Model: Model-J CF		Date: 4-Mar-02	No.: RG570001
Subject: Language Software History		Prepared by: H. Someya	
From: Technical Services Dept., GTS Division			
Classification:	<input type="checkbox"/> Troubleshooting	<input type="checkbox"/> Part information	<input type="checkbox"/> Action required
	<input type="checkbox"/> Mechanical	<input type="checkbox"/> Electrical	<input type="checkbox"/> Service manual revision
	<input type="checkbox"/> Paper path	<input type="checkbox"/> Transmit/receive	<input type="checkbox"/> Retrofit information
	<input checked="" type="checkbox"/> Other ()

Model: Model-J CF		Date: 15-Mar-02	No.: RG570002
Subject: Remarks at firmware update		Prepared by: T. Itoh	
From: Technical Services Dept., GTS Division			
Classification:	<input type="checkbox"/> Troubleshooting	<input type="checkbox"/> Part information	<input checked="" type="checkbox"/> Action required
	<input type="checkbox"/> Mechanical	<input type="checkbox"/> Electrical	<input type="checkbox"/> Service manual revision
	<input type="checkbox"/> Paper path	<input type="checkbox"/> Transmit/receive	<input type="checkbox"/> Retrofit information
	<input type="checkbox"/> Other ()

Model: Model-J CF		D

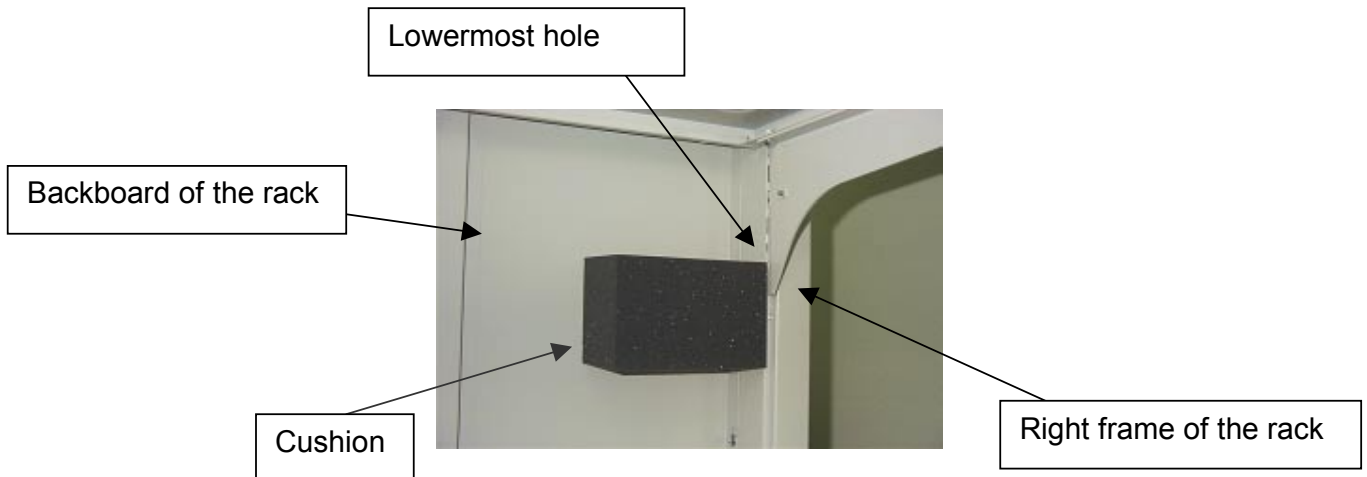
The right frame of the CF Rack can pinch the IPU connector, causing an SC error (mainly SC672) to occur, or a blank operation panel display at power on.

Attach the cushion shown below to the backboard of the CF Rack before docking the rack and mainframe. This cushion has been packed with the CF Expander Unit from the serial numbers listed below.

NOTE 1: When adhering the cushion to the backboard, make sure to position it flush against the surface of the rear face of the right frame, just below the lowermost hole in the frame.

2. CAUSE

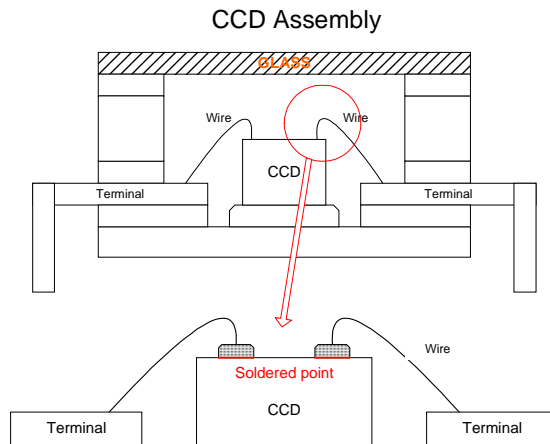
The adhesive used to attach the glass to the CCD assembly was changed. However, it generated a gas when exposed to the heat from the PCB during machine operation. The gas caused the soldered points of wires on the CCD to oxidize and deteriorate, resulting in poor contact.

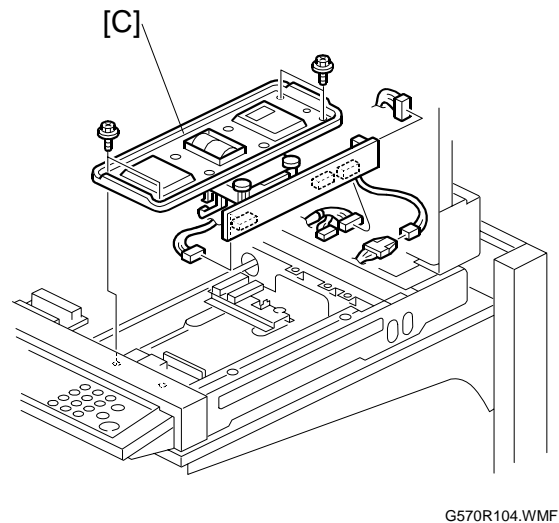
1. Open the ARDF/platen cover
2. Exposure glass
3. Rear cover
4. Right cover [A] (⚙ x 3)
5. Inner cover [B] (⚙ x 4)

6. Lens block assembly (Sensor board unit) [C] (⚙ x 4, 🛠 x 4)

Note: Do not remove the paint-locked screws.

7. After replacing the lens block assembly (Sensor board unit), adjust the following SP modes according to the scanner adjustment procedure on the following page.
 - SP4-008 (Scanner leading edge magnification)
 - SP4-010 (Scanner leading edge registration)
 - SP4-011 (Scanner side-to-side registration)

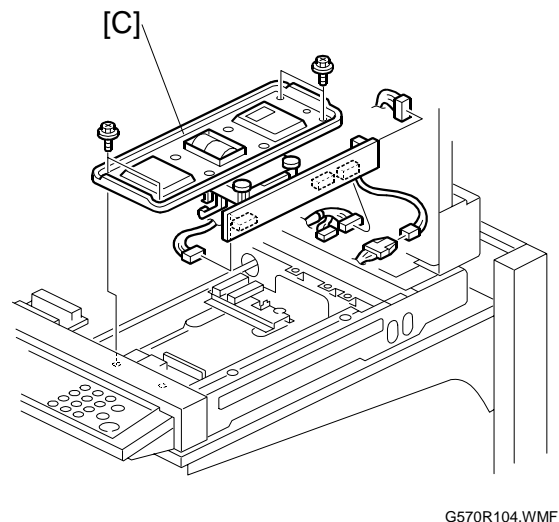
1. Open the ARDF/platen cover
2. Exposure glass
3. Rear cover
4. Right cover [A] (⚙ x 3)
5. Inner cover [B] (⚙ x 4)

6. Lens block assembly (Sensor board unit) [C] (⚙ x 4, ⚙ x 4)

Note: Do not remove the paint-locked screws.

7. After replacing the lens block assembly (Sensor board unit), **check that the current setting of SP4-205 (Black ADS Level) is at its default of 70.**
